# ADDENDUM NO. 3

### November 28, 2022

# JACKSON ELEMENTARY SCHOOL RENOVATIONS Valparaiso, IN 46304

This Addendum consists of page ADD 3-1 and attached Addendum No. 3 from Gibraltar Design dated November 23, 2022 and consisting of 7 pages and 42 drawings.

**UNIT "A" ARCHITECTURAL** FIRST FLOOR DEMOLITION PLAN

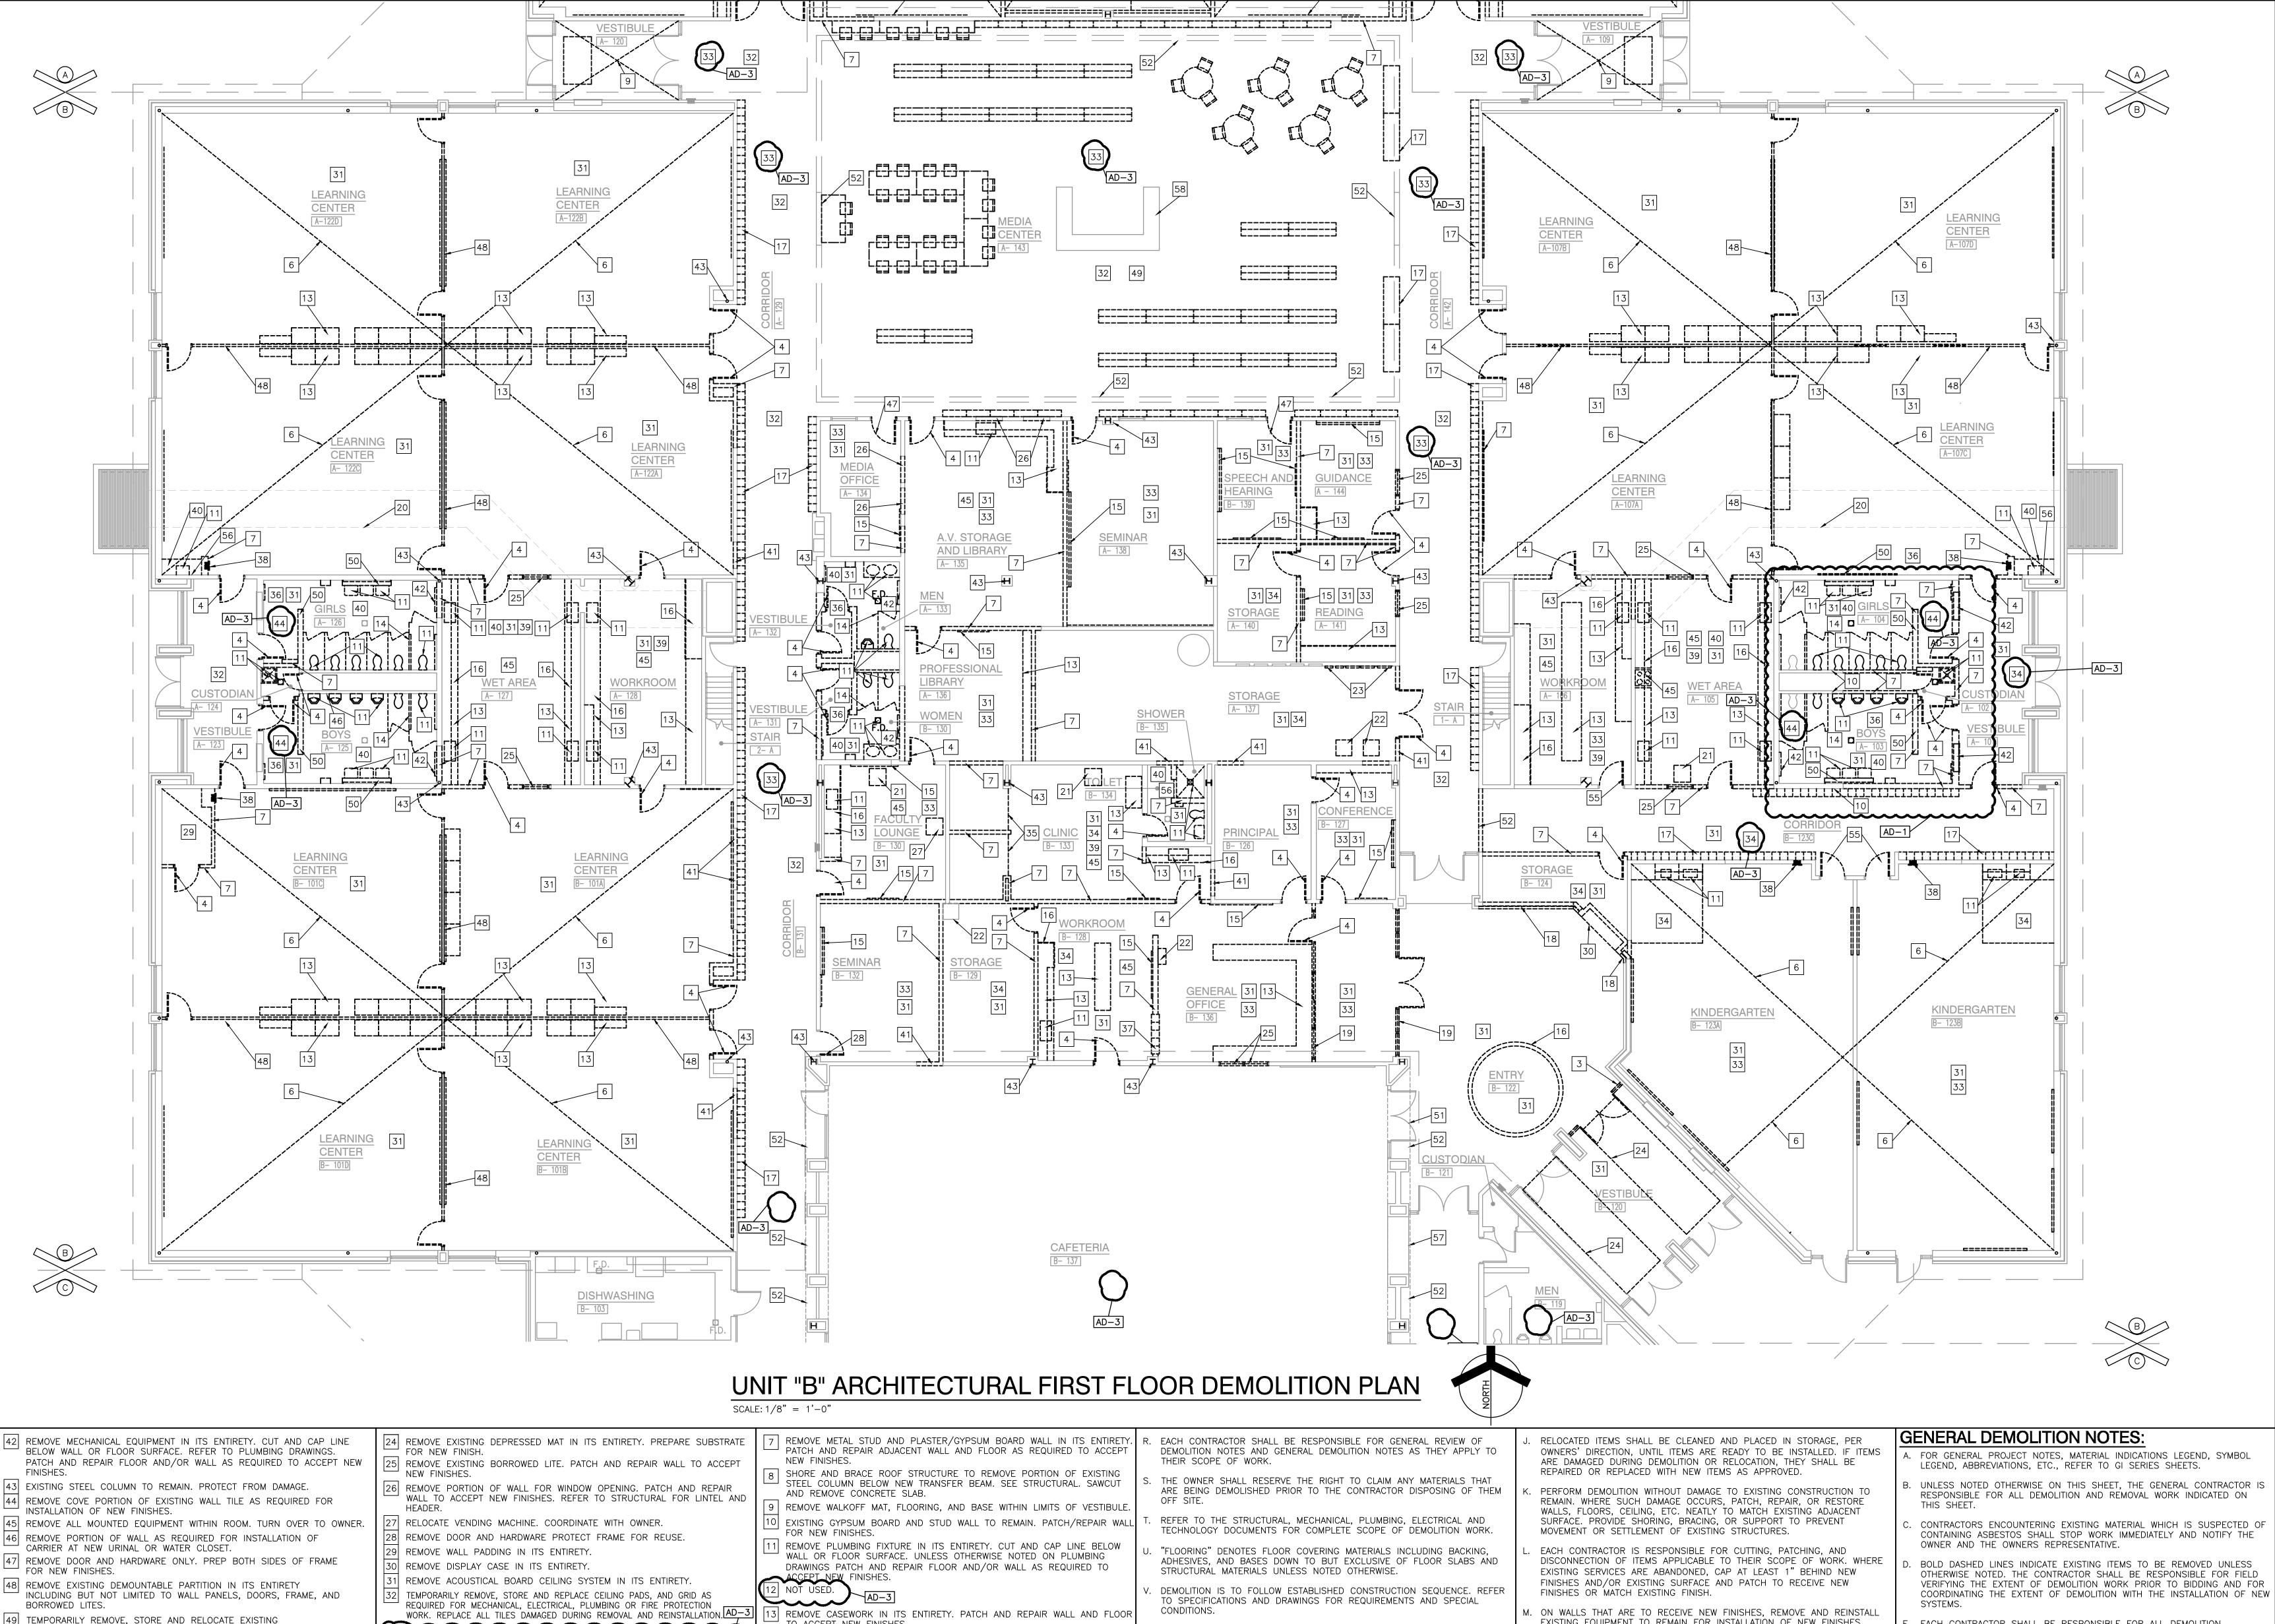
- A. Refer to revised full size drawing, included in this Addendum, for the following revisions:
  - 1. Change Demolition Plan Note 12 to "Not Used".
  - 2. Add Note 33 outside Vestibule A-109 and Vestibule A-120.
  - 3. Add Note 44 to Boys A-114 and Girls A-115.
  - 4. Revise Note 33 to clarify the removal of carpet base.
  - 5. Add Carpet Base Demo Detail to sheet.

AD102

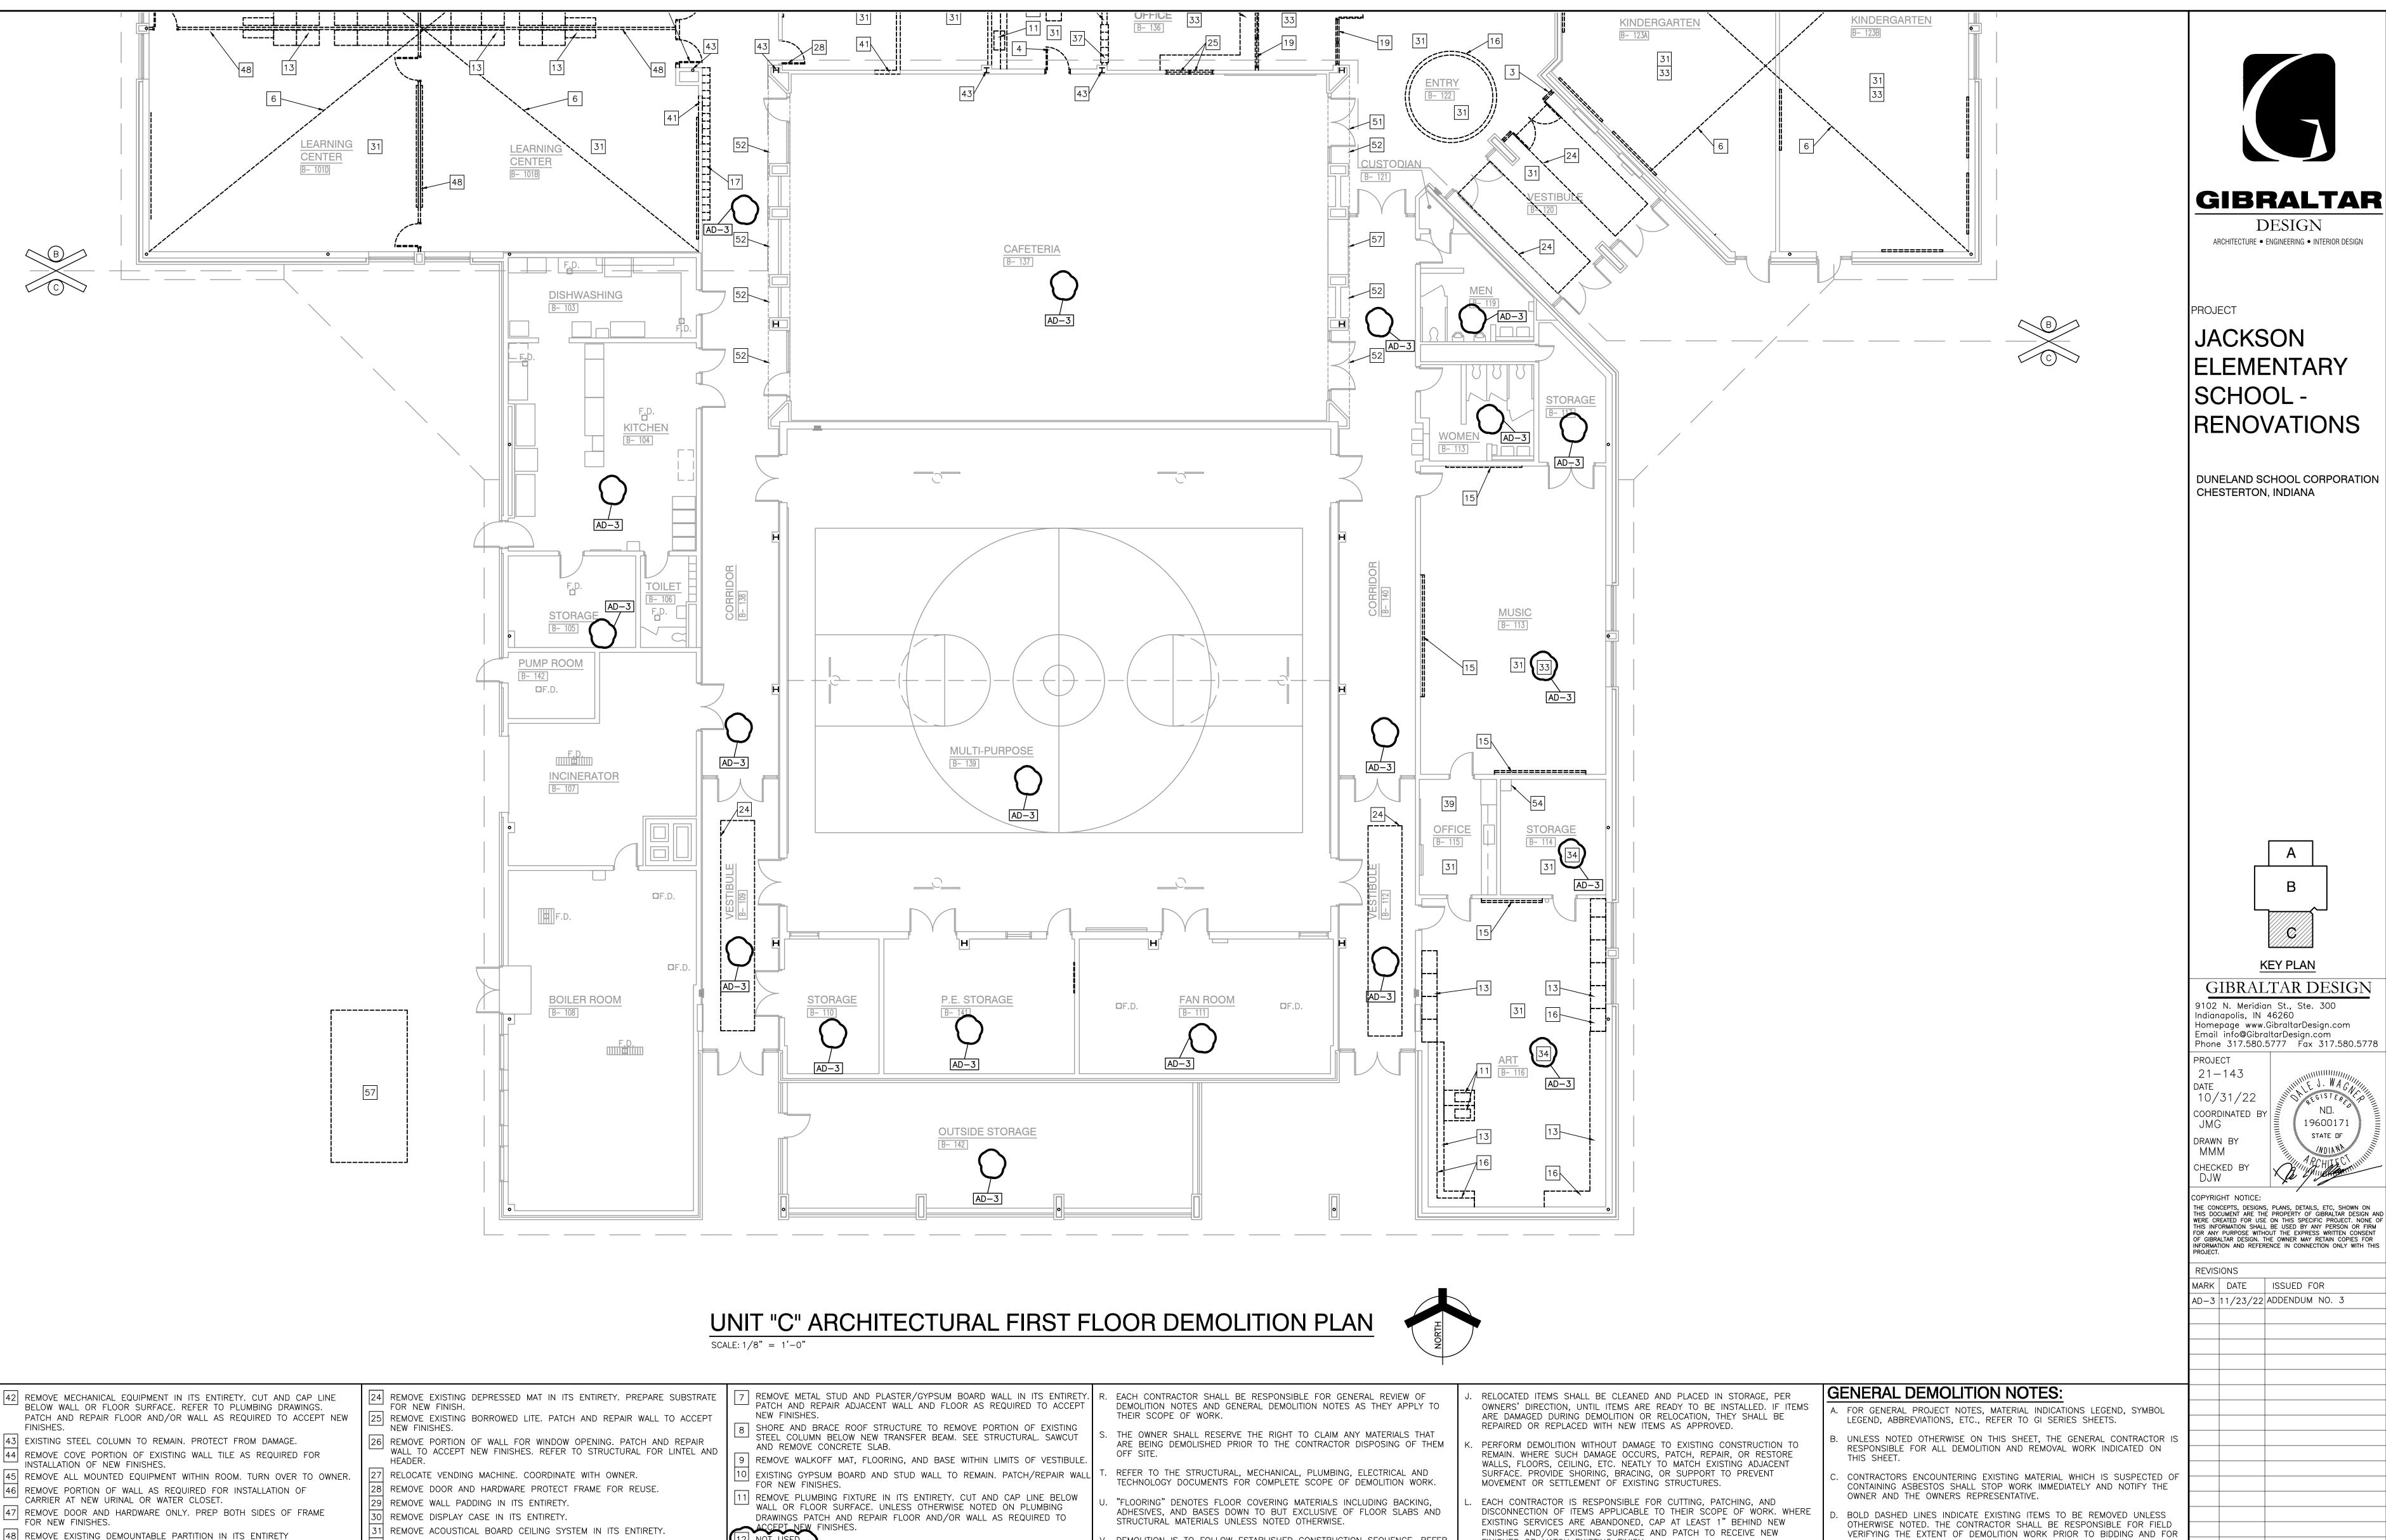
- A. Refer to revised full size drawing, included in this Addendum, for the following revisions:
  - 1. Change Demolition Plan Note 12 to "Not Used".
  - 2. Remove Note 32 where indicated.
  - 3. Add Note 33 to Corridor A-142, Media Center A-142, Corridor A-129, and Corridor B-131.
  - 4. Add Note 34 to Vestibule A-101 and Corridor B-123C.
  - 5. Add Note 44 to Boys A-103, Girls A-104, Boys A-125, and Girls A-126.
  - 6. Revise Note 33 to clarify the removal of carpet base.

UNIT "C" ARCHITECTURAL FIRST FLOOR DEMOLITION

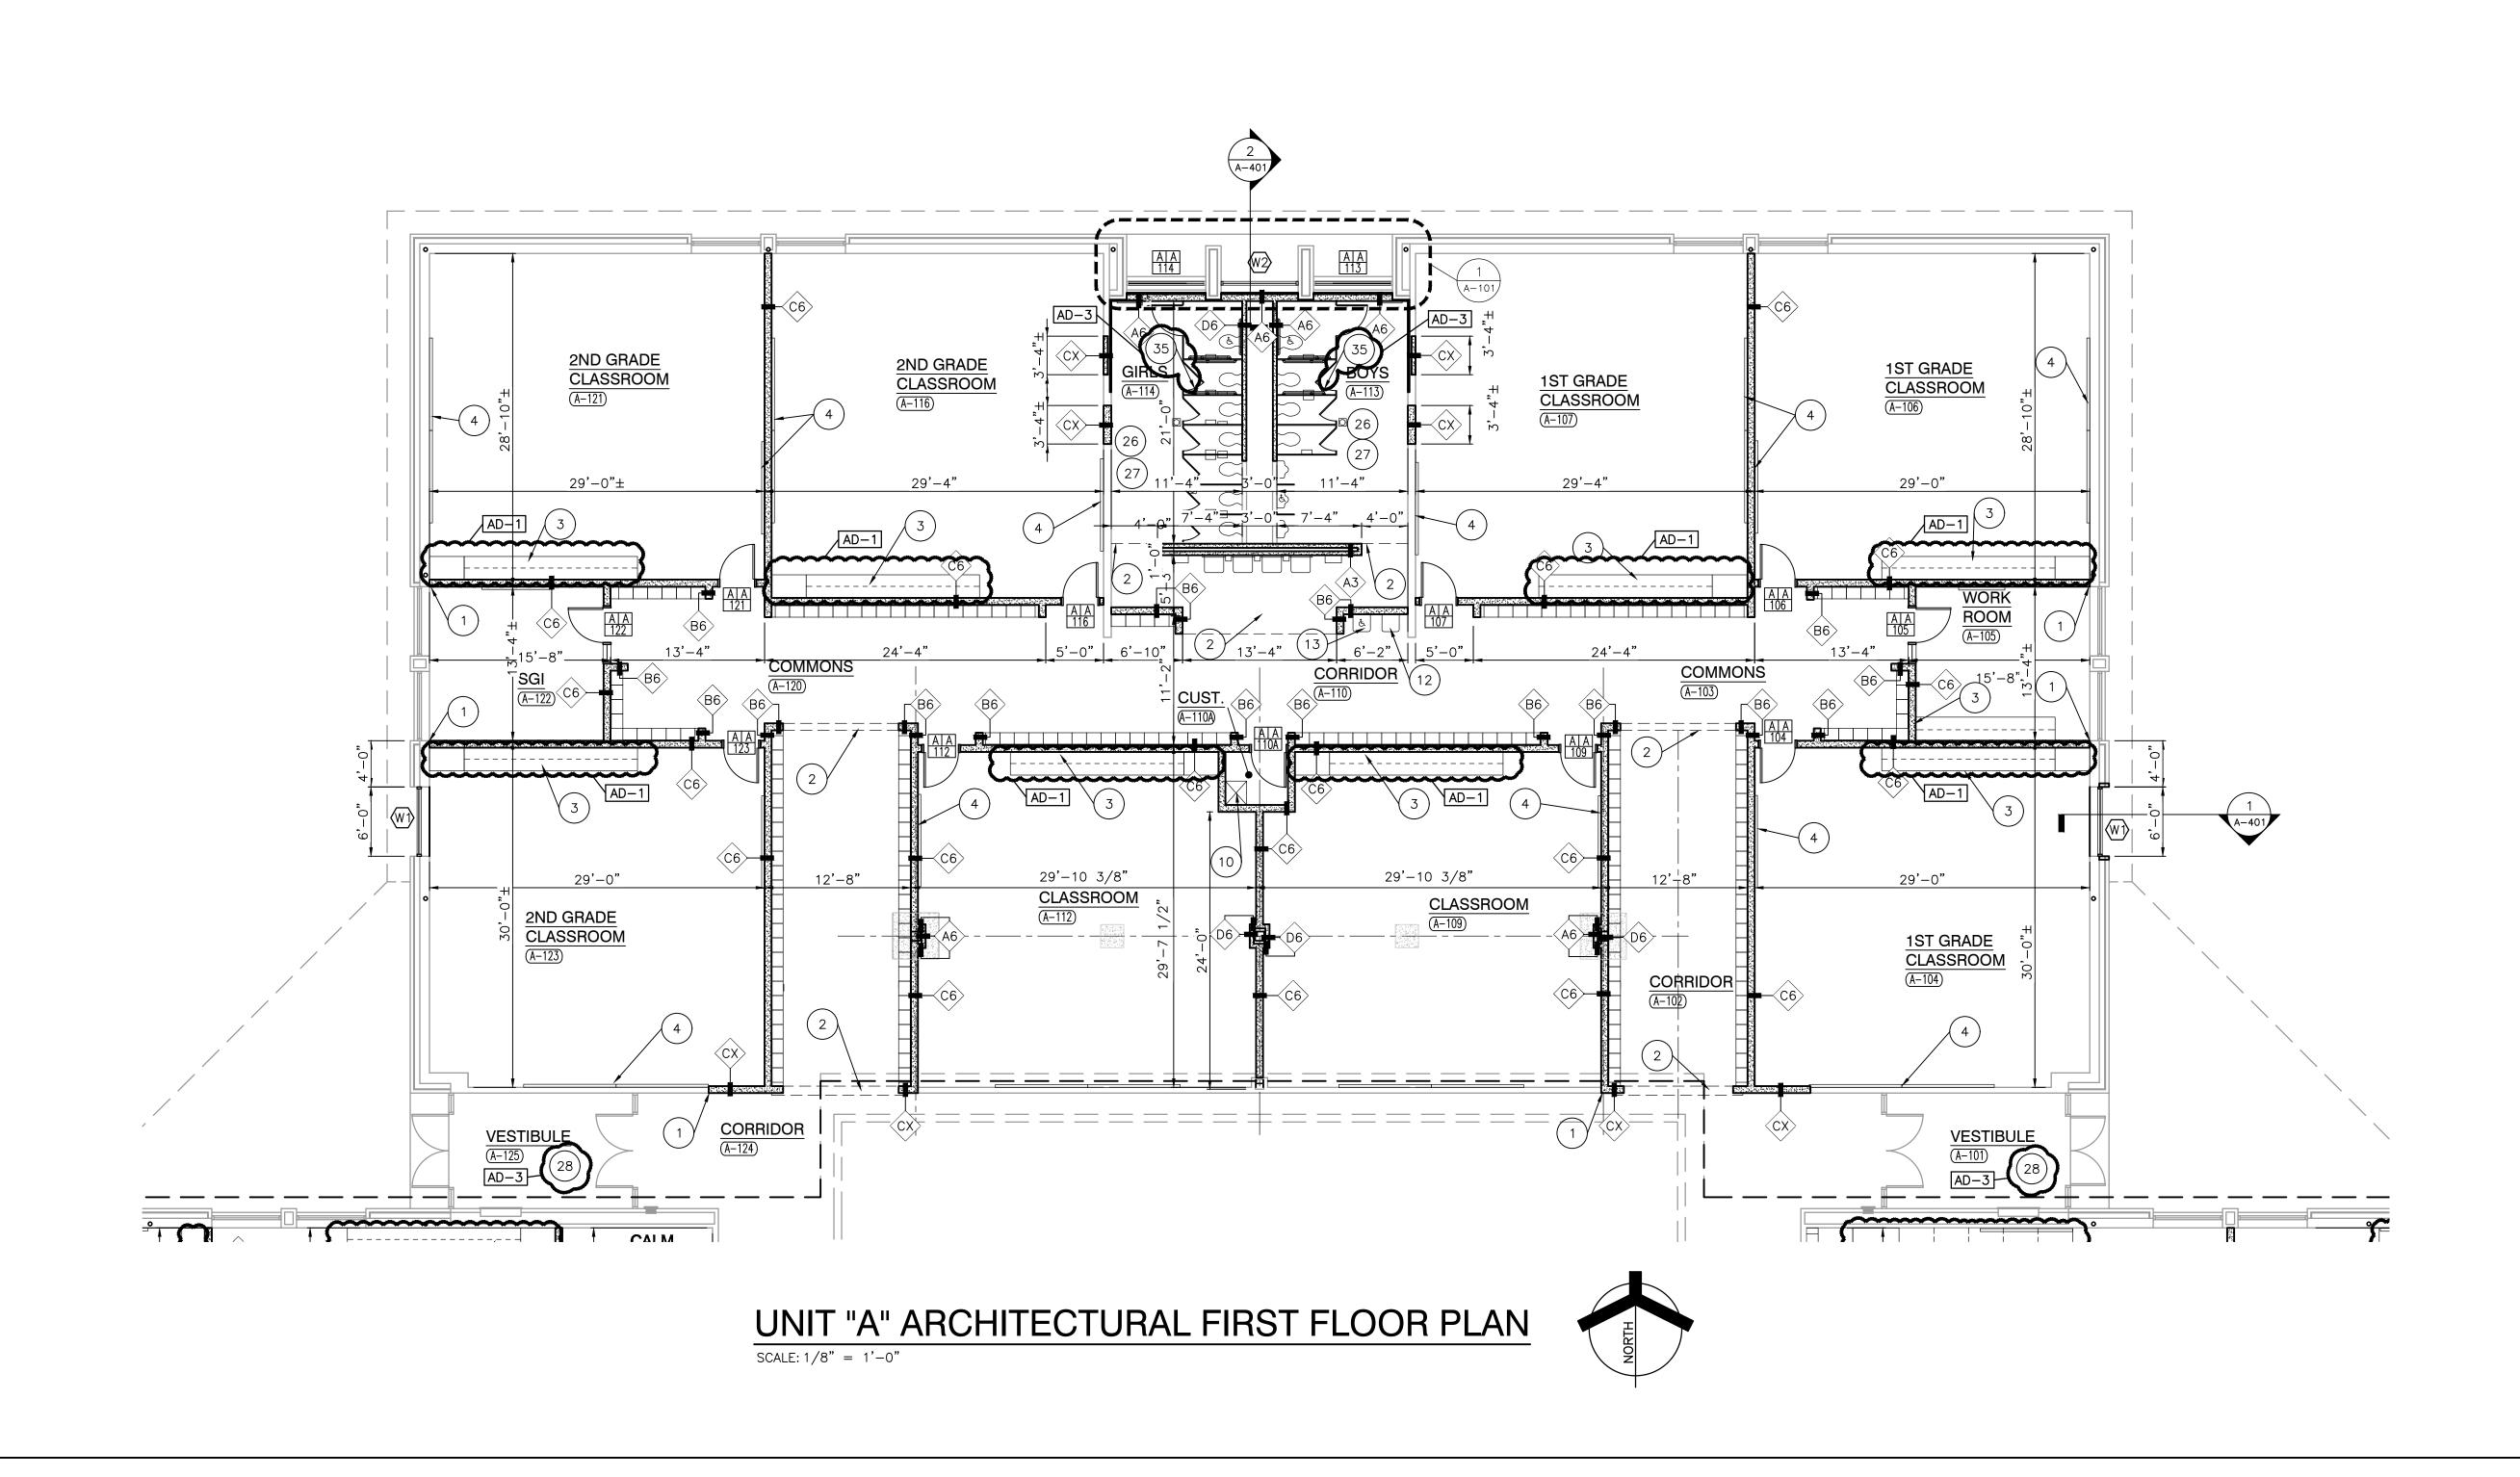
- A. Refer to revised full size drawing, included in this Addendum, for the following revisions:
  - 1. Change Demolition Plan Note 12 to "Not Used".
  - 2. Remove Note 32 where indicated.
  - 3. Add Note 33 to Music B-113.
  - 4. Add Note 34 to Storage B-114 and Art B-116.
  - 5. Revise Note 33 to clarify the removal of carpet base.
